<b>Title - Sujet</b> Workstations	
<b>Solicitation No. - N° de l'invitation</b> 45045-170027/A	<b>Amendment No. - N° modif.</b> 002
<b>Client Reference No. - N° de référence du client</b> 000009790	<b>Date</b> 2017-10-24
<b>GETS Reference No. - N° de référence de SEAG</b> PW-\$\$\$PQ-981-73552	
<b>File No. - N° de dossier</b> pq981.45045-170027	<b>CCC No./N° CCC - FMS No./N° VME</b>
<b>Solicitation Closes - L'invitation prend fin</b> <b>at - à 02:00 PM</b> <b>on - le 2017-11-01</b>	<b>Time Zone</b> <b>Fuseau horaire</b> Eastern Daylight Saving Time EDT
<b>F.O.B. - F.A.B.</b> <b>Plant-Usine:</b> <input type="checkbox"/> <b>Destination:</b> <input type="checkbox"/> <b>Other-Autre:</b> <input type="checkbox"/>	
<b>Address Enquiries to: - Adresser toutes questions à:</b> MacIsaac, James	<b>Buyer Id - Id de l'acheteur</b> pq981
<b>Telephone No. - N° de téléphone</b> (819) 639-4357 ( )	<b>FAX No. - N° de FAX</b> ( ) -

## Amendment 002

This amendment is raised to extend the closing date and to publish questions and answers.

8th Floor  
Furniture Plan

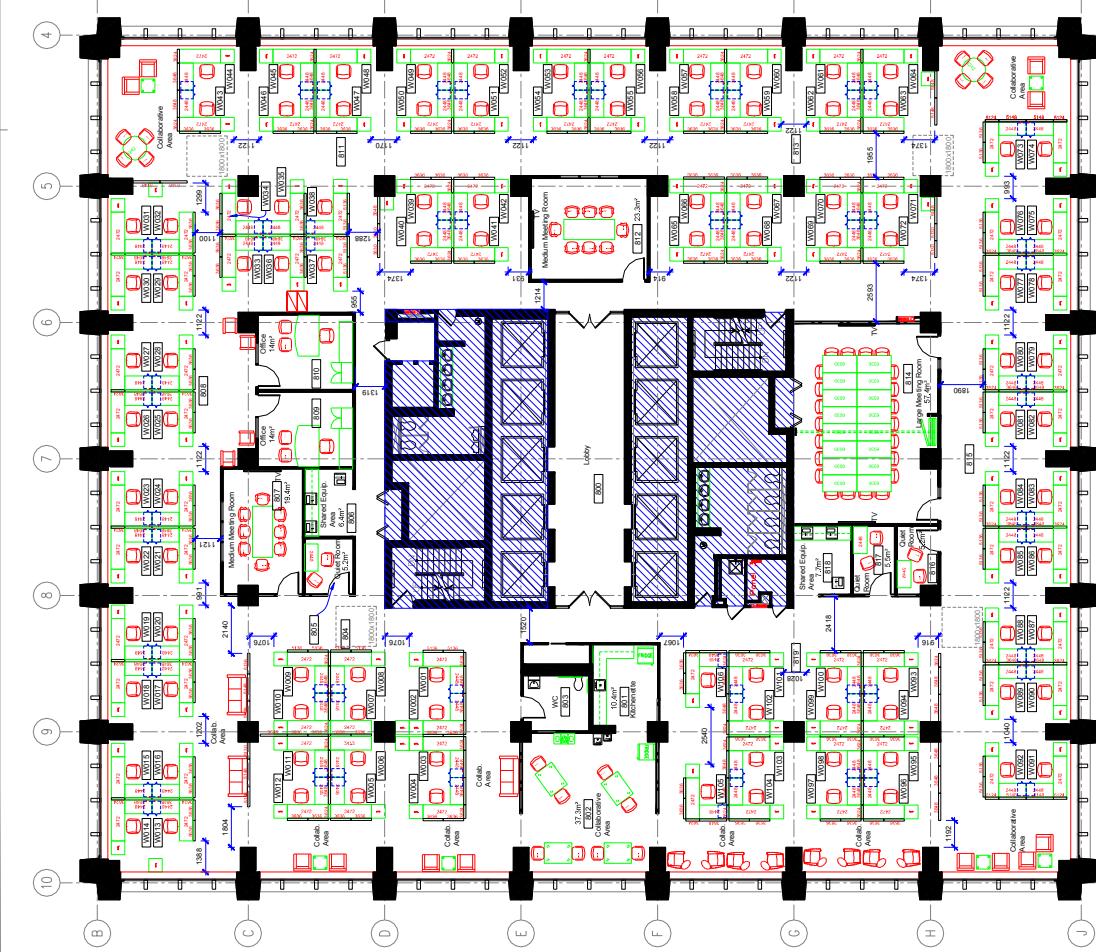
Question 13: Is it possible to get a copy of the DWG files?

**Answer 13: No. Relevant PDF drawings are provided only. See additional sketches:**

- [45045-170027A\\_SK-01\\_RHCoats 8-10 Furniture.pdf](#): SK-01 for furniture dimension information on Floors 8 and 10
- [45045-170027A\\_SK-01\\_RHCoats 6-9 Furniture.pdf](#): SK-02 for furniture dimension information on Floors 6 and 9
- [45045-170027A\\_SK-03 to 05\\_Glazed Element Locations.pdf](#)
  - SK-03 for location of glazed panels on Floors 8 and 10
  - SK-04 for location of glazed panels in Wing 1405
  - SK-05 for location of glazed panels on Floors 6 and 9

SK-03

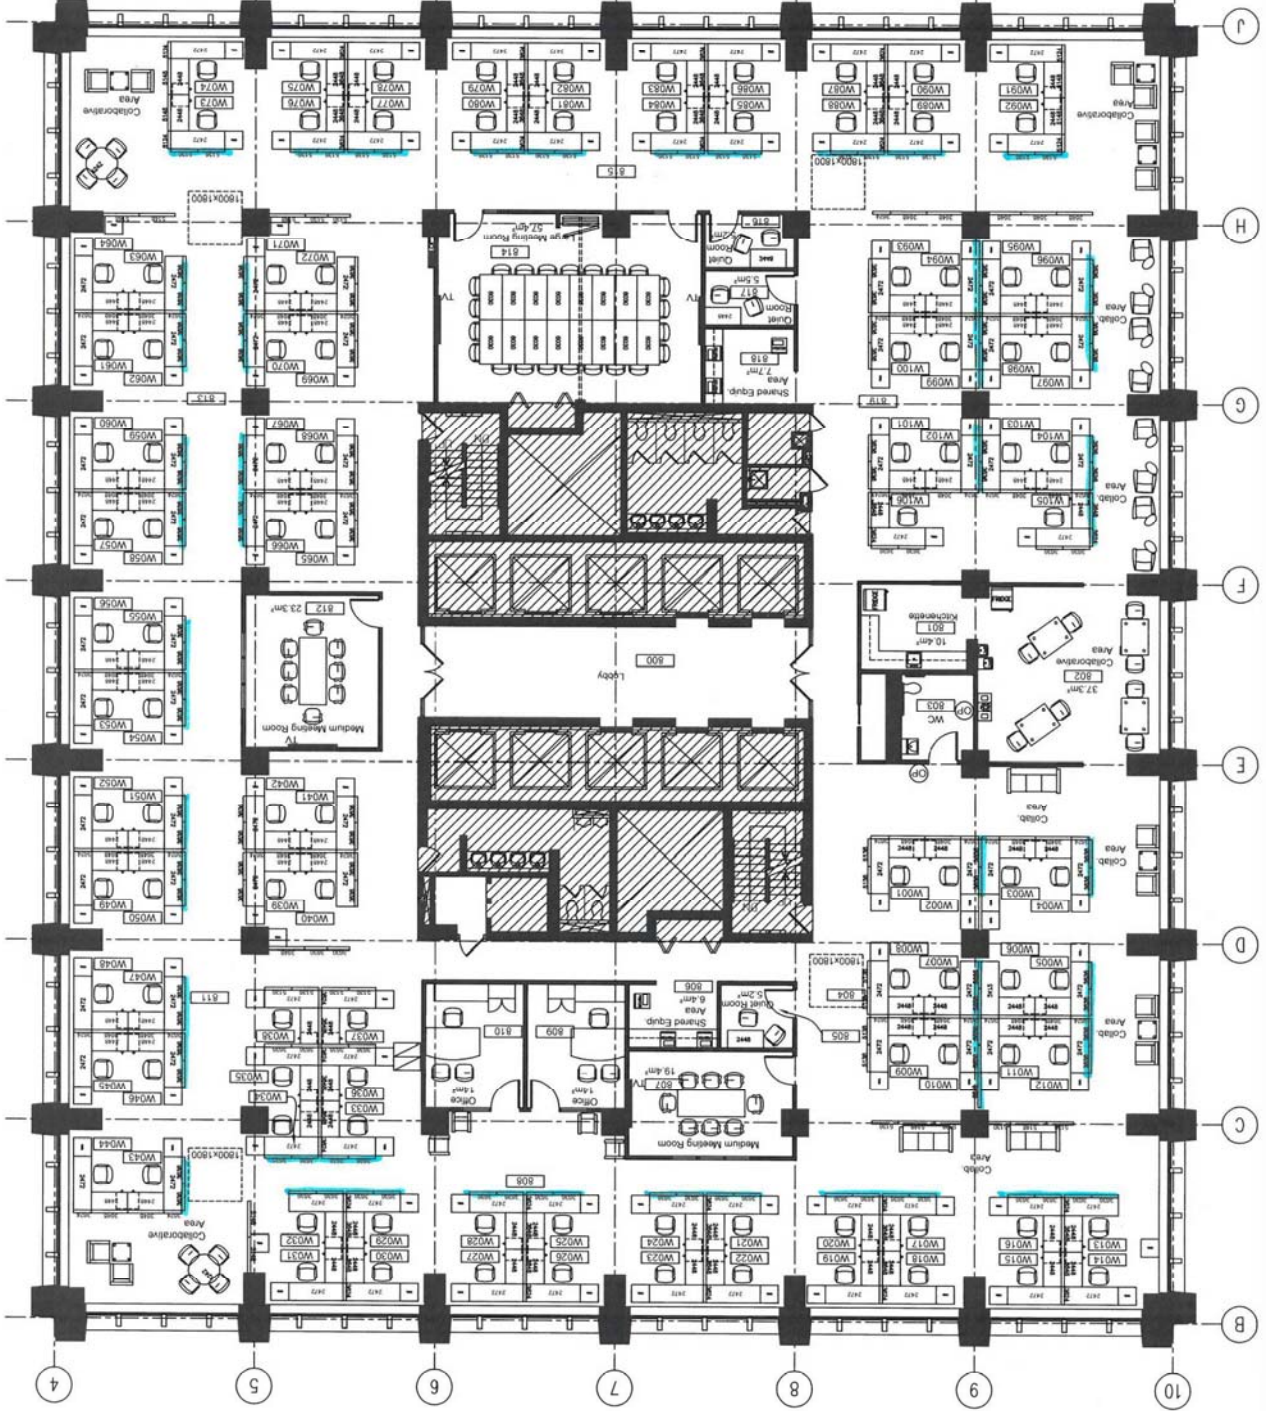
Question 11: Page 21 – (4) Panel Matrix – Main Building - Wing 1405

- Panel Matrix 1 – Seated Privacy Height – Upper Element 1 and 2
- Panel Matrix States “Glass”, can you confirm if this is clear or frosted?

**Answer 11: All ‘glass’ upper panel elements are to be changed to ‘glazed’ and provided as ‘frosted’. ‘Clear glazed’ elements are to all be changed to ‘frosted glazed’ elements.**
